ISSUE: Certificate of Appropriateness for alterations (small cell facility)

APPLICANT: AT&T Mobility

Dominion Energy utility pole near 432 South Columbus Street

STAFF RECOMMENDATION

Figure 1 - Existing light concrete pole

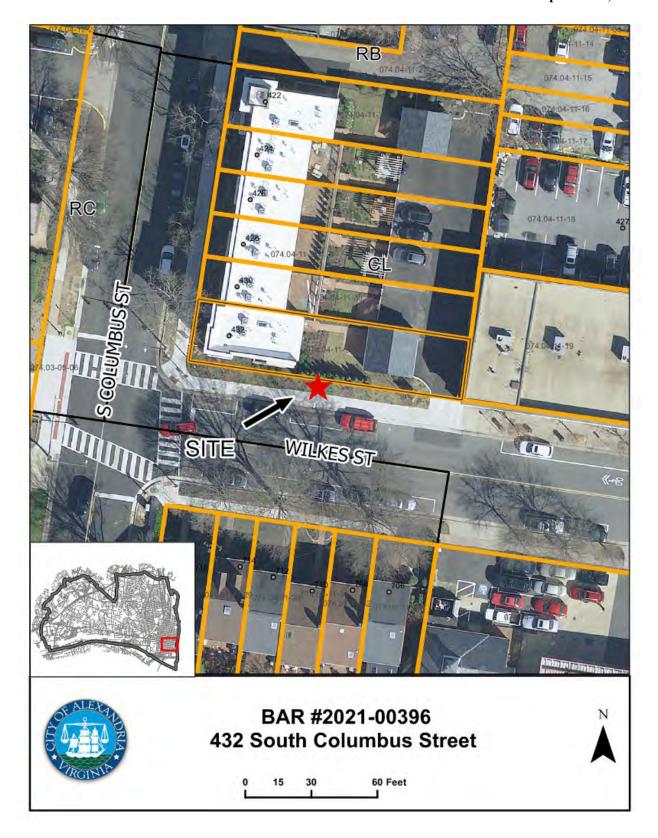
The subject concrete pole is located near to the northeast corner of the intersection of South Columbus and Wilkes streets (Figure 1)

Figure 2 - Design A-8 approved by the City Council

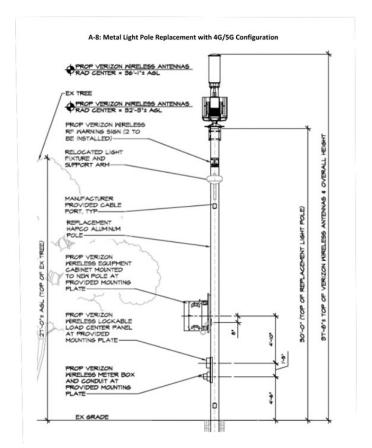
The proposed pole design is the A-8 Metal Light Pole Replacement with 4G and 5G Configuration approved by the City Council in December 2020 (Figure 2).

The overall height of the new pole including the small cell facility is 38'-5". BAR staff has no objection to the taller metal pole or the installation of the small cell facility in this location and finds that painting the equipment the same color as the pole will make them less obvious. The existence of utility poles and overhead wires, street signs, and light poles are part of the urban streetscape, and staff does not believe that the installation of the taller pole with the small cell equipment will adversely impact existing viewsheds.

Therefore, staff recommends approval of the Certificate of Appropriateness as submitted.
